**NUMBER:** 09-001-07

**DATE:** March 14, 2007

**THIS BULLETIN SUPERSEDES TECHNICAL SERVICE BULLETIN 09-009-06, DATED SEPTEMBER 09, 2006, WHICH SHOULD BE REMOVED FROM YOUR FILES. ALL REVISIONS ARE HIGHLIGHTED WITH **\*\*ASTERISKS\*\*** AND INCLUDES THE ADDITION OF A CLEAN POINT IN THE MODELS SECTION.**

Intake-to-Throttle Body Joint May Cause A Whistle-Like Sound On 3.7L Engines

**Fig. 1 INTAKE-TO-THROTTLE BODY JOINT**

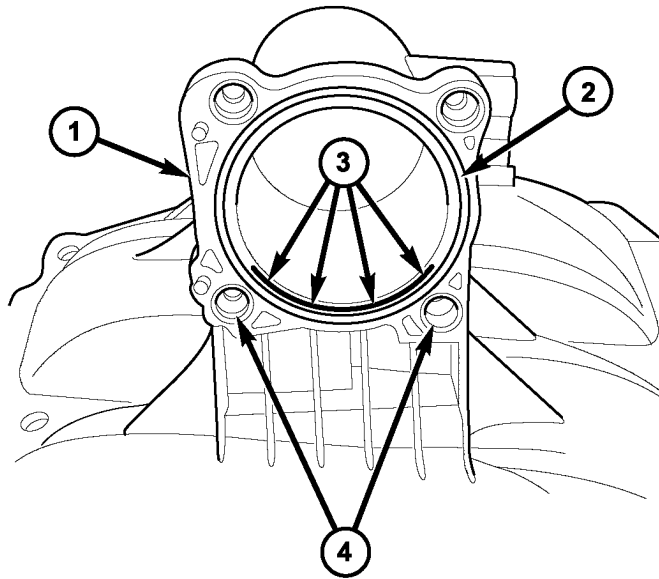
1. Disconnect and isolate the negative battery cable from the battery.
2. Remove the Electronic Throttle Control (ETC) throttle body from the intake manifold. For detailed service information refer to TechCONNECT, select the Service Info tab > 14 - Fuel System > Fuel Injection - Gas > Throttle Body > Removal or Installation > Throttle Body - 3.7L.
3. Apply a very small diameter bead (1 mm) of RTV to the intake manifold-to-throttle body joint. The RTV is to be applied to the lower section of the joint between the lower two throttle body bolt attachment holes (Fig. 1). **A very small amount of RTV is needed to seal the slight space/gap on the inner surface of the joint.** The gap was created by a slight taper in the intake manifold joint surface.

- 1 - Intake Manifold
- 2 - Intake-to-Throttle Body Gasket
- 3 - Apply Very Small Diameter Bead Of RTV Between Two Lower Bolt Holes
- 4 - Two Lower Bolt Holes

**NOTE: Do not apply an excessive amount of RTV to the joint.**

- 4. Install the ETC throttle body to the intake manifold. Tighten the throttle body four attaching bolts to 7 Nm (60 in. lbs.).

**NOTE: Wipe off inside joint of any excess RTV squeeze-out.**
